Re: Response to January 19, 2012 DRC/URS Comments on Nitrate Corrective Action Plan – Docket No. UGW09-03

Please find enclosed Denison Mines (USA) Corp.'s ("Denison's") revisions, dated February 27, 2012, to the *Nitrate Corrective Action Plan for the White Mesa Mill Site* (the "Plan").

This revision has been prepared in response to comments from the Utah Division of Radiation Control and URS Corporation dated January 19, 2012. The revision has been provided in both clean and track changes ("redline") format for ease of review.

APPROVED SJS	DATE	REFERENCE H:/718000/ nov11/nitrate/Ndgcptrv2.srf	FIGURE 13
-----------------	------	--	--------------

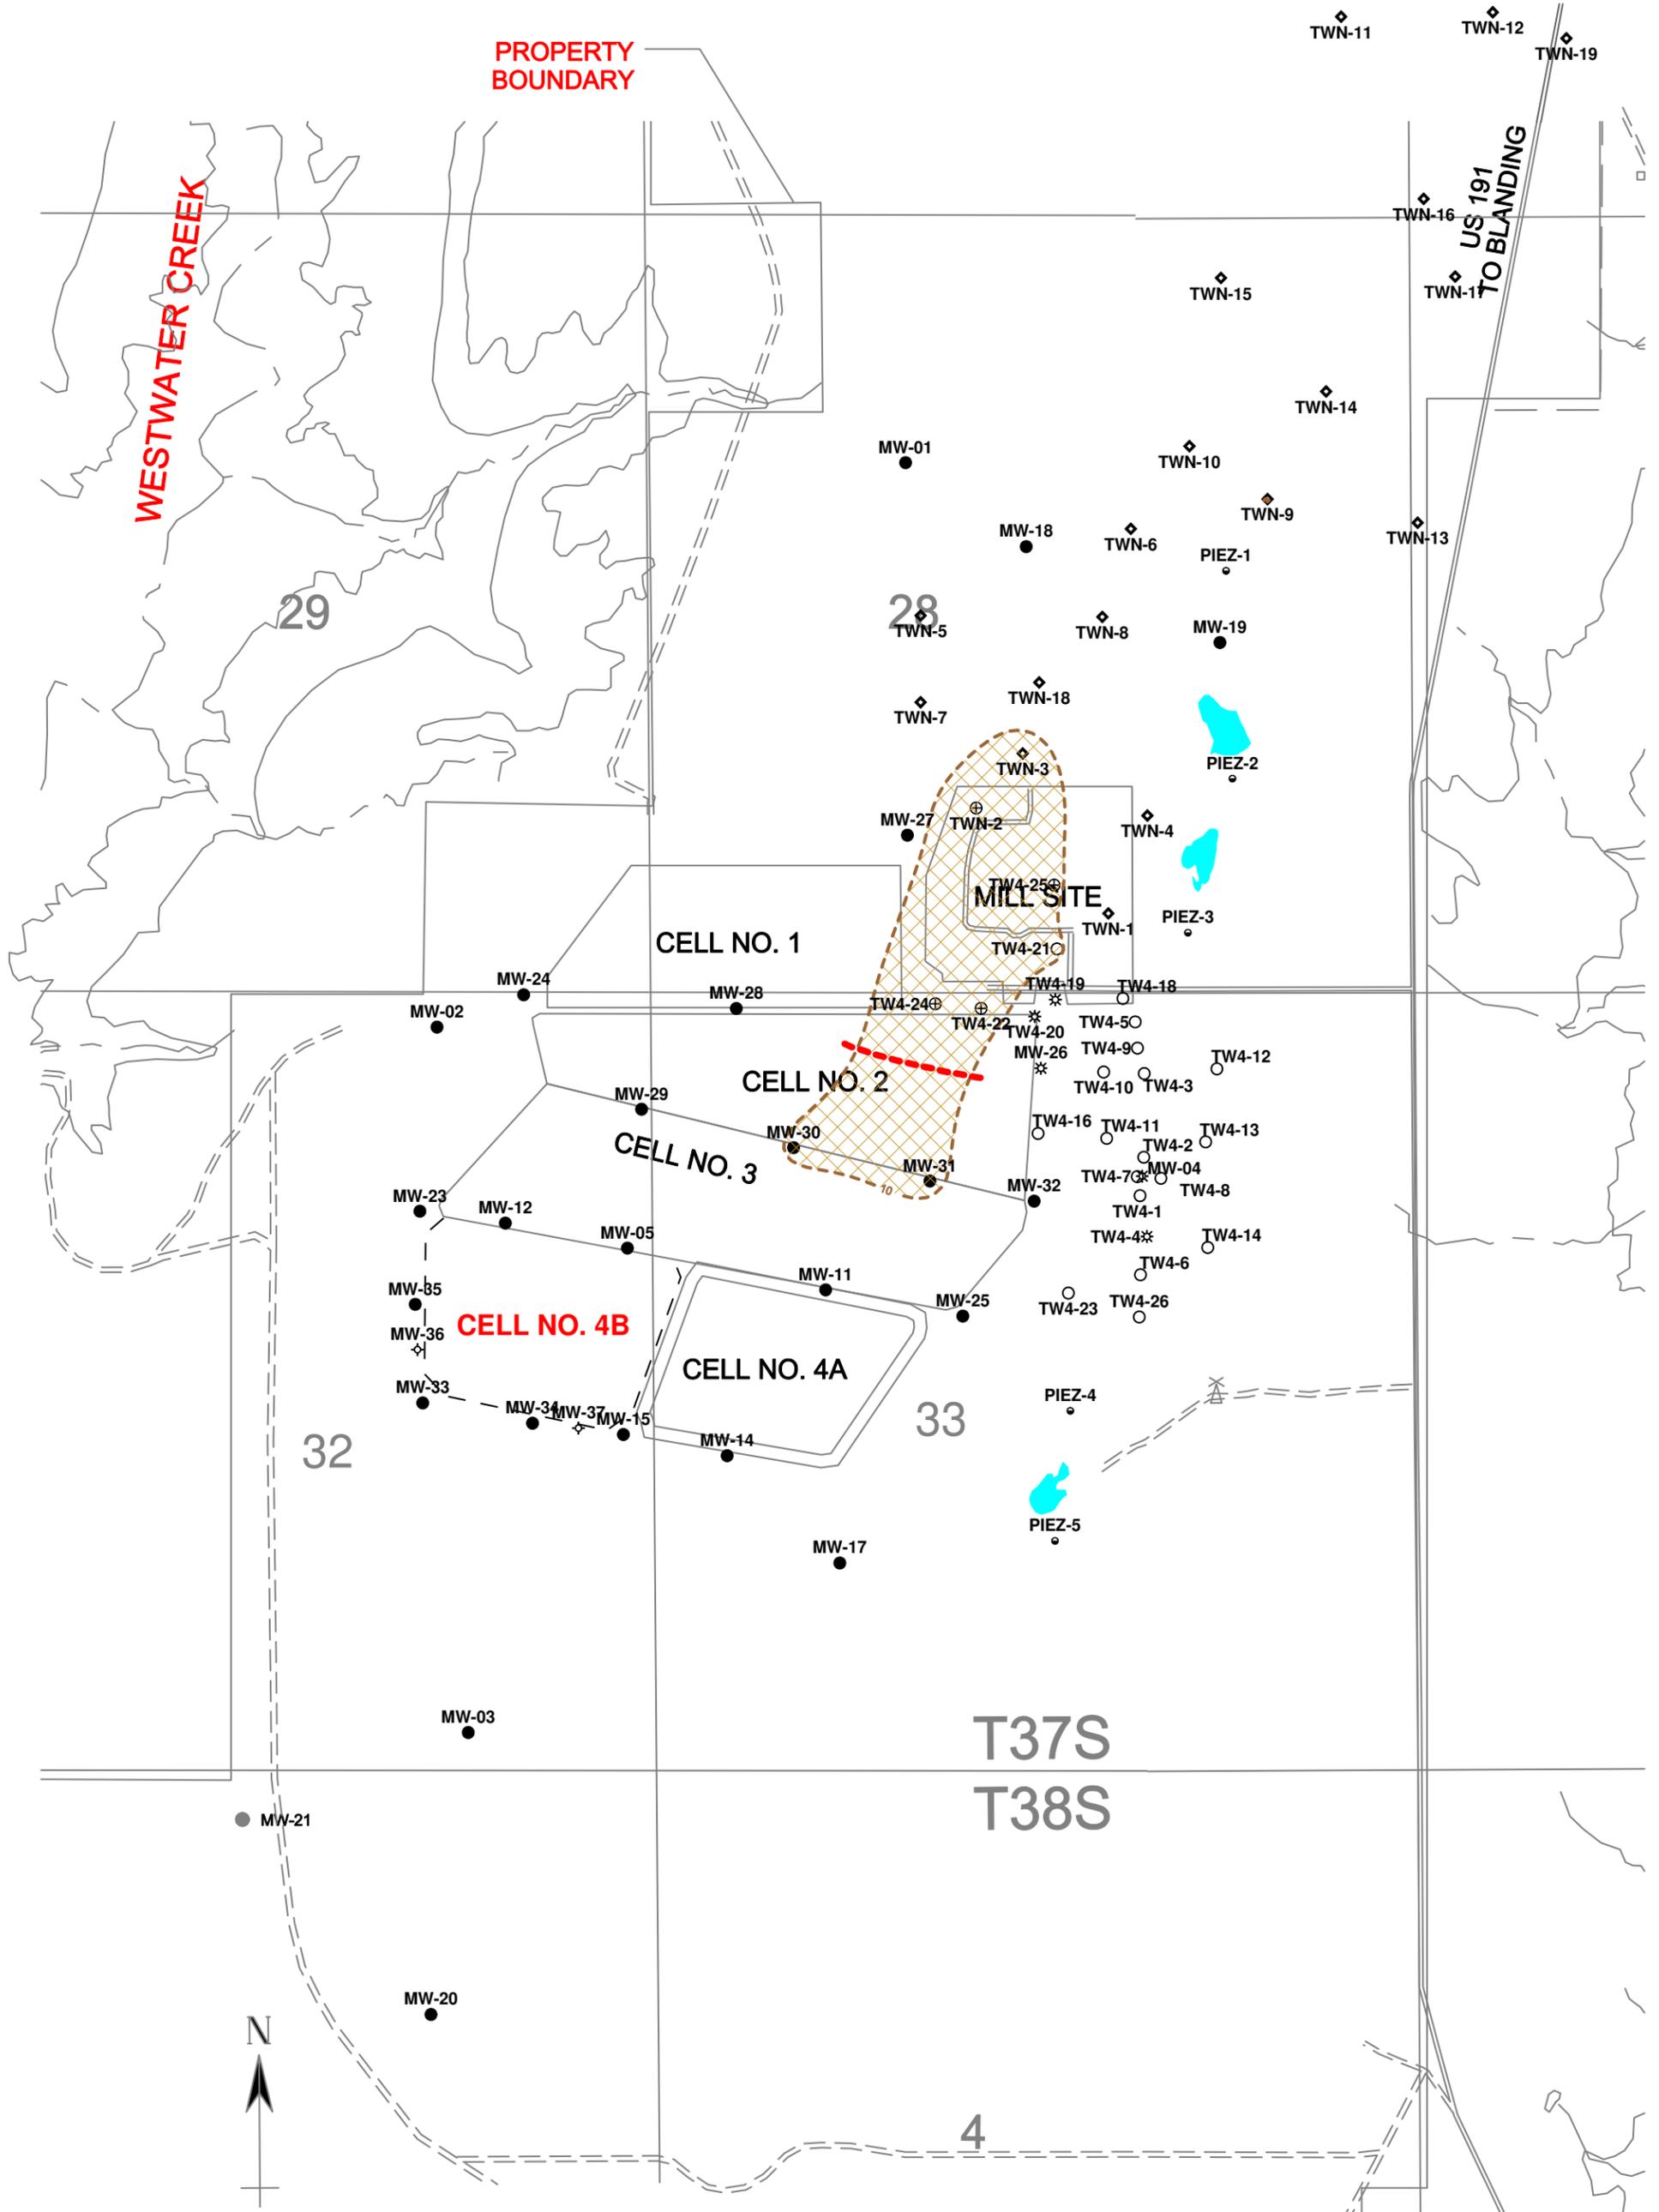
6. The typographical error in Section 1, paragraph 4 has been corrected as requested.
7. The symbols used on Figure 13 have been revised as requested.
8. The text change in Section 2.2 has been made as requested. The deletion has been made as requested.

33. The deletion and change to Section 8.6 have been made as requested.
34. The 10 mg/L contour line in each of Figures 7 and 13 has been changed from solid to dashed as requested.
35. The results in Figure 11-1 have been reported as mg/kg on a dry weight basis as requested.

APPROVED	DATE	REFERENCE	FIGURE
SJS	5/24/11	H:/718000/nitrate2011/ CAP/AppA/CAPxsswnever2.srf	A.2

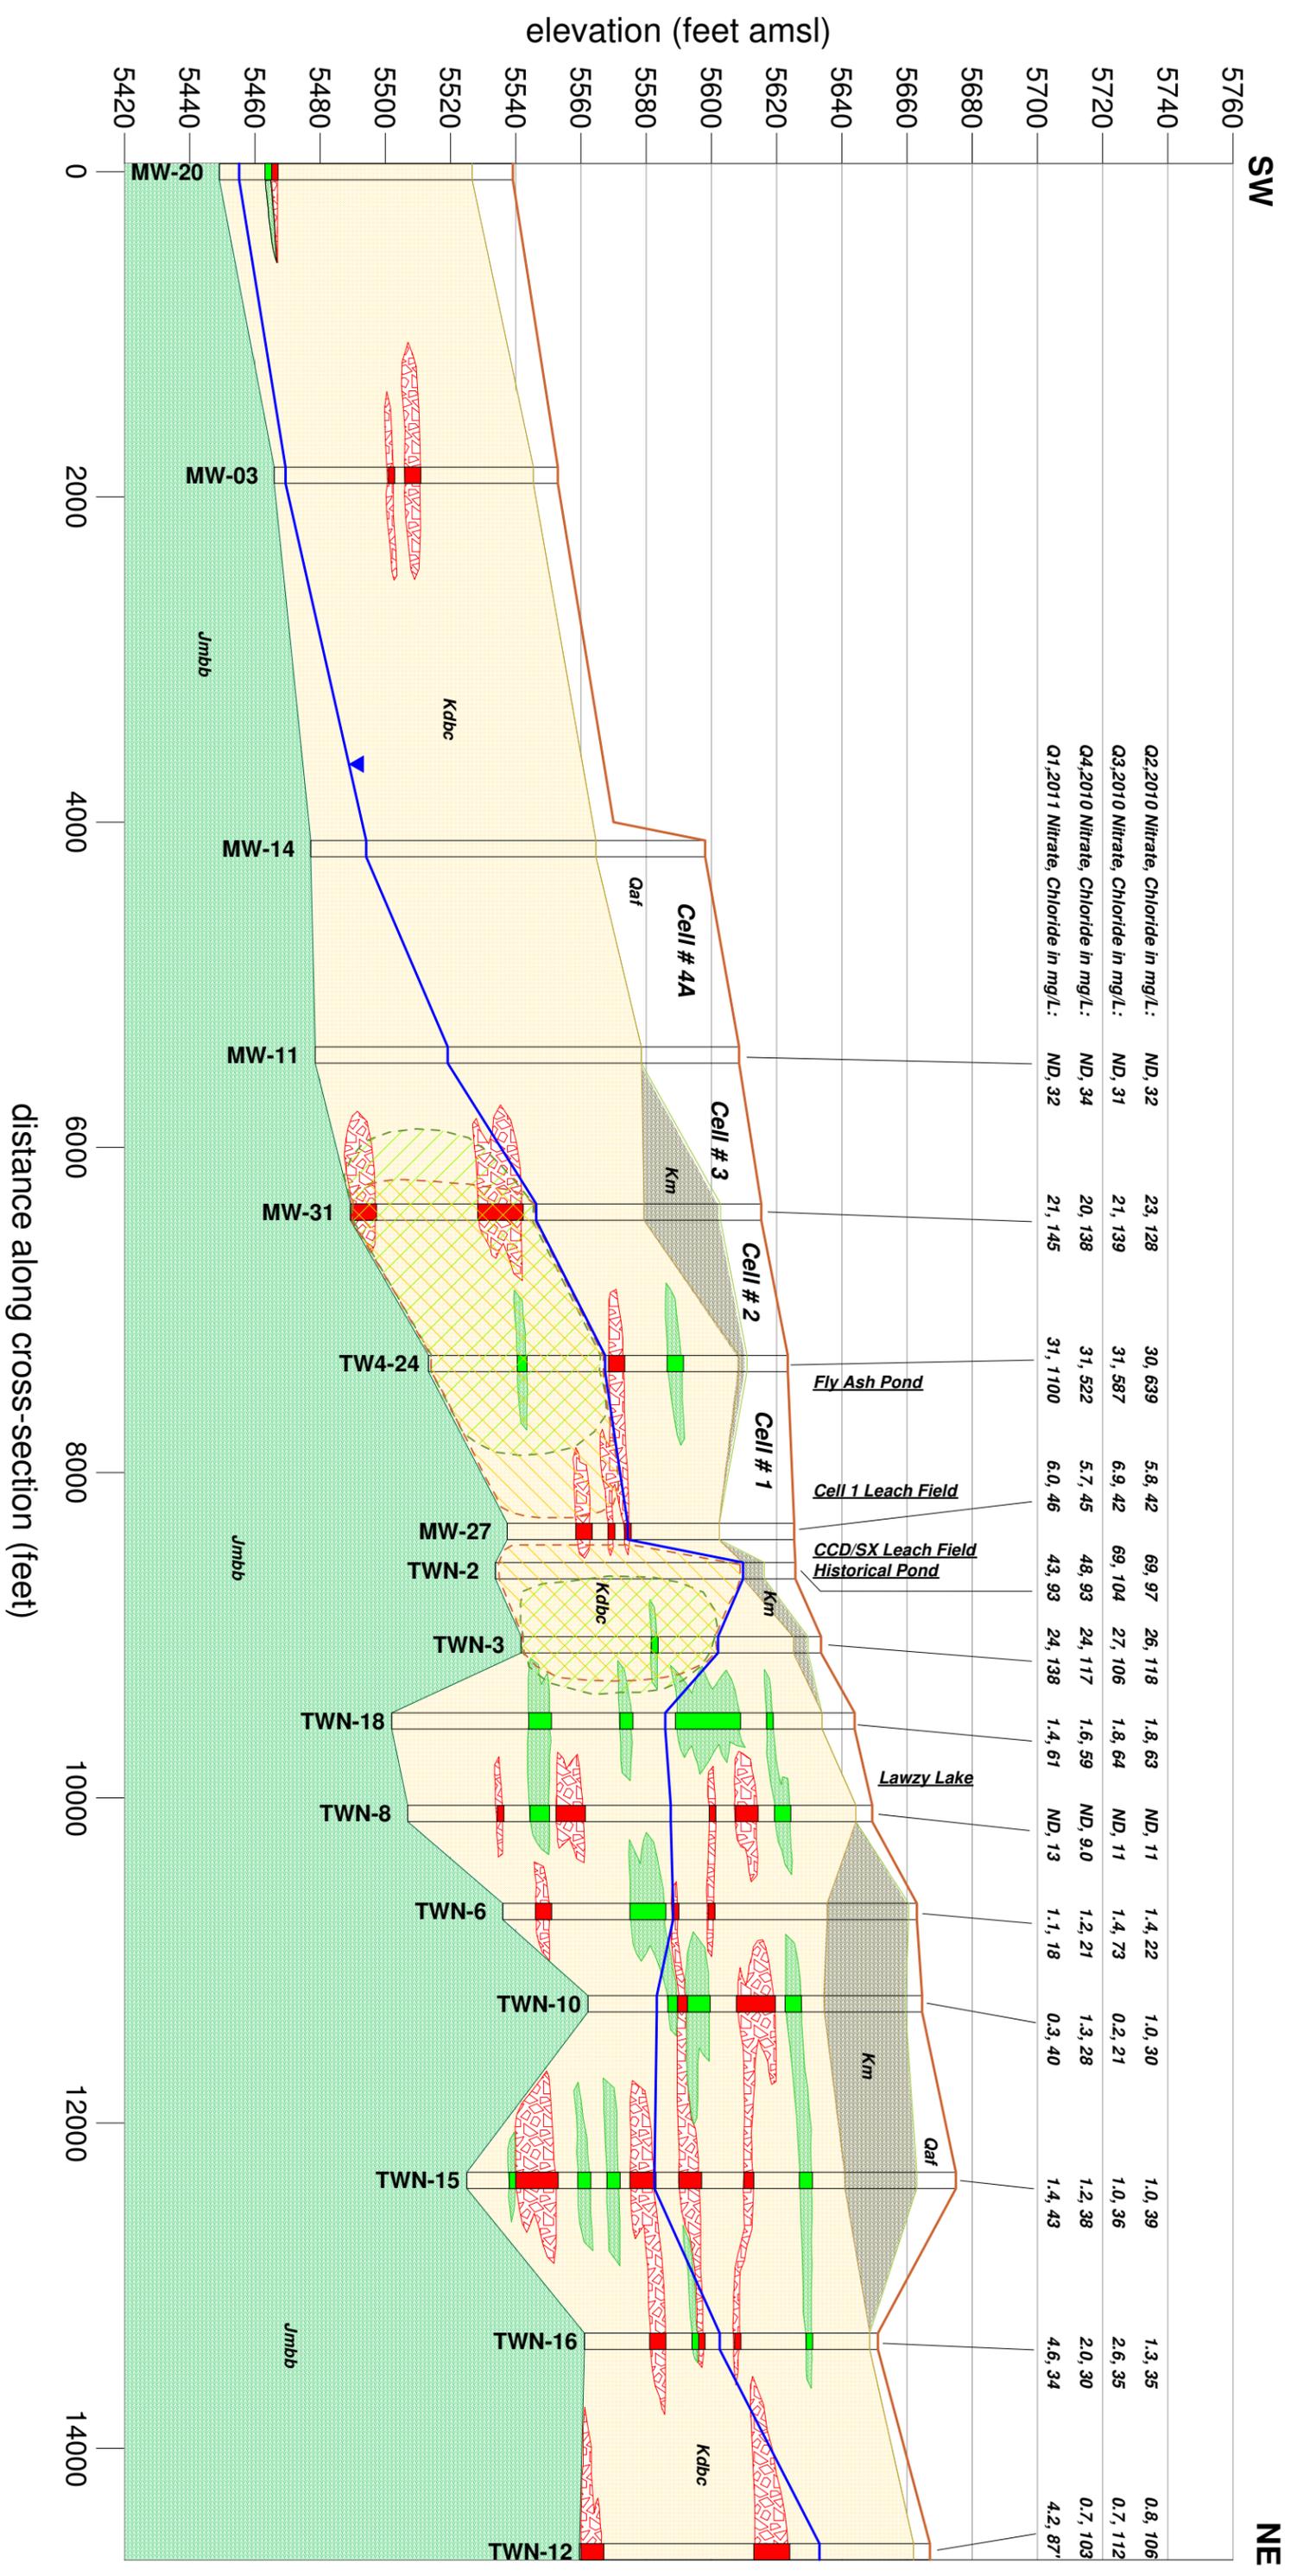
11. Figure A.2 has been modified to be more consistent with the kriged contour maps.
